May 19, 2016

Serial: BSEP 16-0024

Subject: Brunswick Steam Electric Plant (BSEP), Unit Nos. 1 and 2  
Renewed Facility Operating License Nos. DPR-71 and DPR-62  
Docket Nos. 50-325 and 50-324  
Notification of Full Compliance with Order EA-12-049, "Order Modifying Licenses with Regard to Requirements for Mitigation Strategies for Beyond Design Basis External Events" and Order EA-12-051, "Order to Modify Licenses With Regard To Reliable Spent Fuel Pool Instrumentation" for BSEP, Units 1 and 2

#### 3 Response to NRC Requests for Additional Information for Reliable Spent Fuel Pool Level Instrumentation

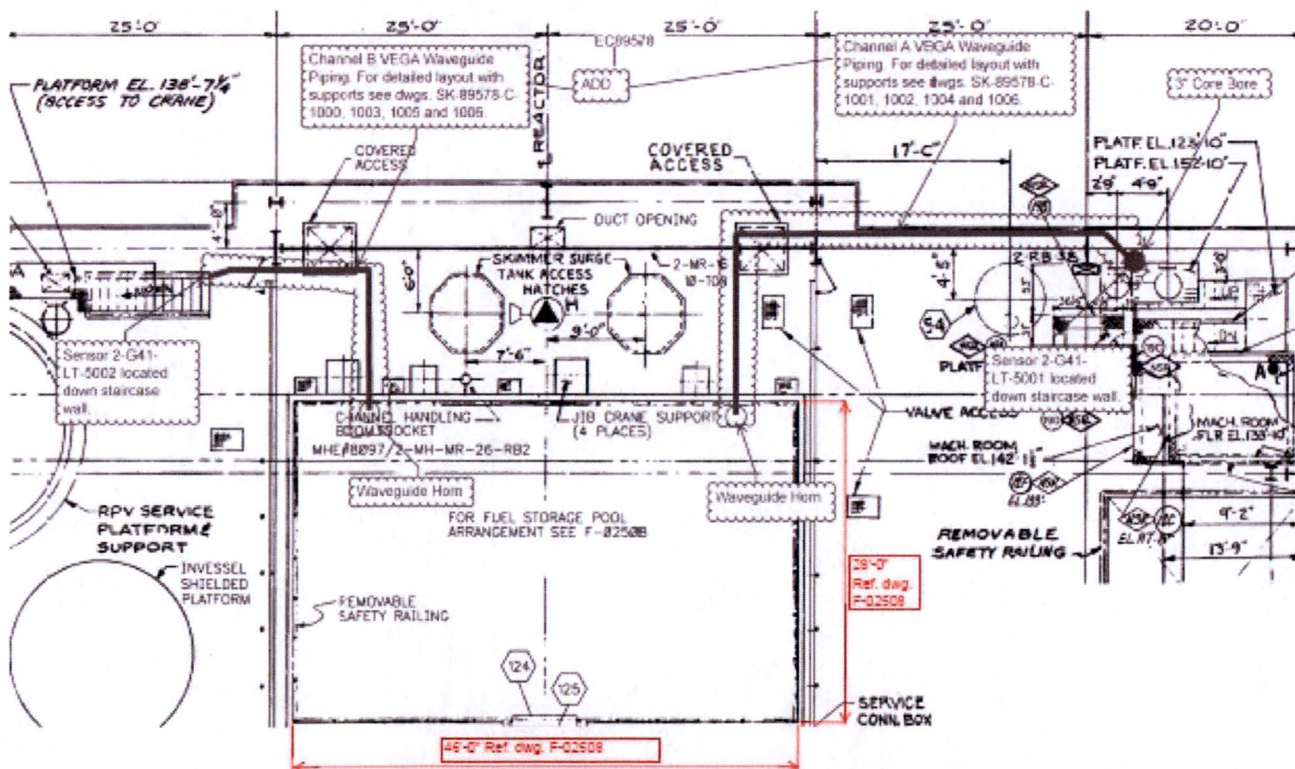
Please provide a clearly labeled sketch or marked-up plant drawing of the plan view of the spent fuel pool (SFP) area, depicting the SFP inside dimensions, the planned locations/placement of the primary and back-up SFP level sensor, and the proposed routing of the cables that will extend from the sensors toward the location of the read-out/display device.

BSEP Units 1 and 2 have similar placement for the SFPLI components. All main components of the Unit 1 system; the waveguide pipe, sensors, and displays locations are similar to Unit 2. The Unit 2 sketches and descriptions are provided below and are representative of both units. Drawing F-02505 is provided in part as sketch SK-89578-M-2000, shown below, which depicts the proposed SFP level channel layout. The primary and back-up SFP level sensors are both new installations per NRC Order EA-12-051 and utilize the same technology. For designation purposes within the RAI responses, Channel A will be called the primary and Channel B will be the back-up level sensor.

As shown on the sketch listed above, both channels are mounted on the North edge of the SFP and are separated by a distance of 36 feet-4 and 7/8 inches. The primary and back-up systems both route to adjacent East and West stairwells respectively and proceed vertically to the elevation below.
